# DRAINAGE AND TRANSPORTATION INFORMATION SHEET

PROJECT TITLE: ABUNDANT LIFE GYMNASIUM ZONE MAP: M-10 D0006  
DRB#:                      EPC#: NA WORK ORDER#: NA

**SUBJECT: ABUNDANT LIFE GYMNASIUM**  
**Grading and Drainage Plan (M10-D0006)**

**RE: Abundant Life Gymnasium  
2851 Arenal Rd SW  
Grading and Drainage Plan  
Engineers Stamp Date 8/18/15 (M10D006)**

# STORMCEPTOR INLET

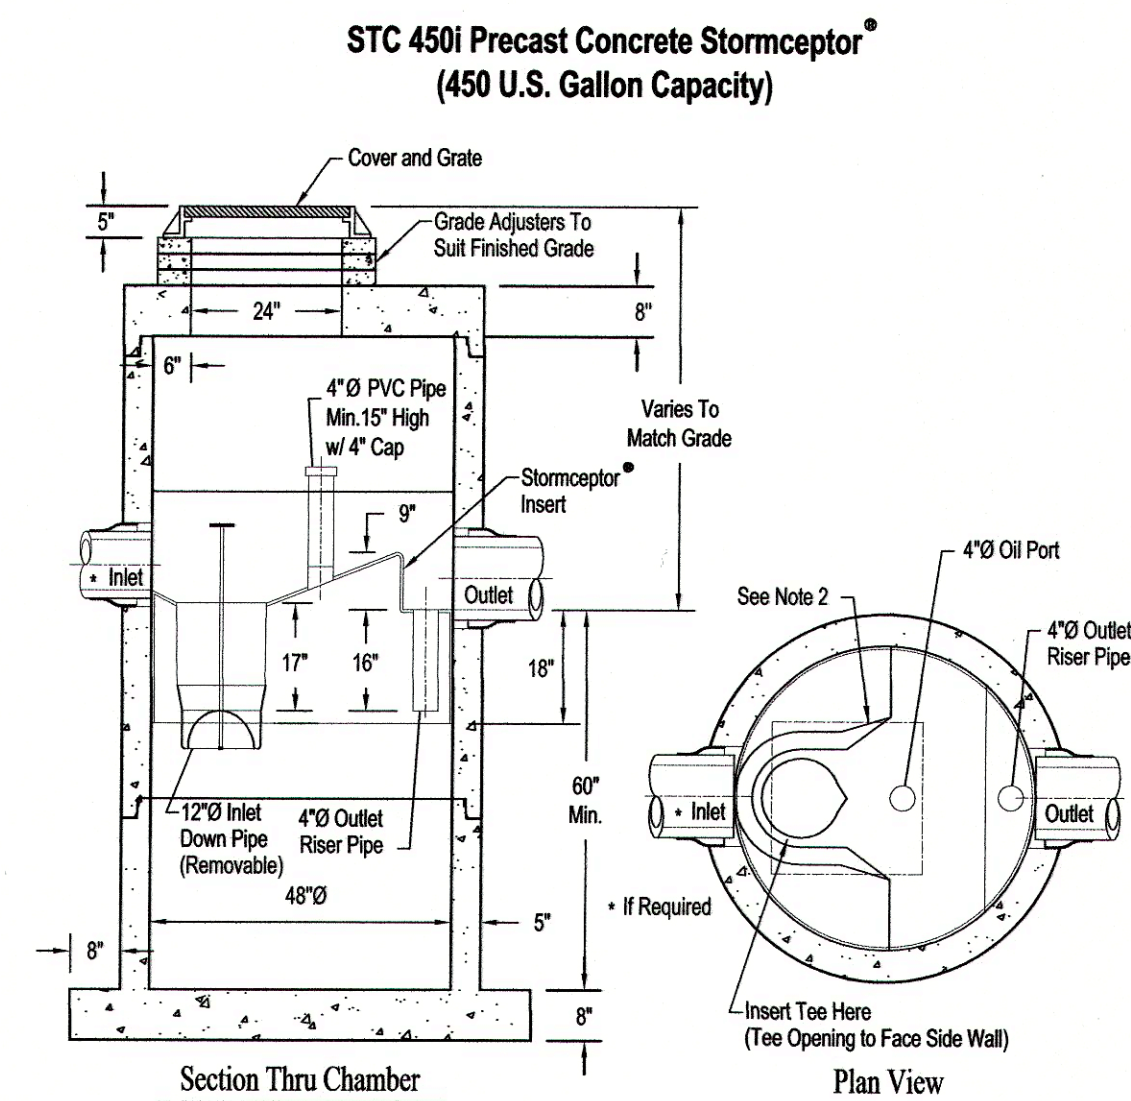
At this time, I will allow the discharge rate you are proposing. However, the first flush "retained" volume must be increased to that generated by 0.60" of rainfall with a total "retained + detained" volume equal to the 100yr. 6hr. runoff volume. We will also need a water quality outlet that will capture oils and trash onsite prior to discharging to the storm drain.

1. The Plan has been submitted to Bernalillo County Public Works for review and approval. Comments issued by Don Briggs are attached. The plan now includes a Stormceptor inlet to remove oils and trash. The First Flush depth is also adjusted. Approval is pending.

2. Two (2) copies of the plan are provided for SO 19 purposes.
3. Detail J/C2.0 has been revised to include a stormceptor manhole that will capture oils and trash as required by Bernalillo County.
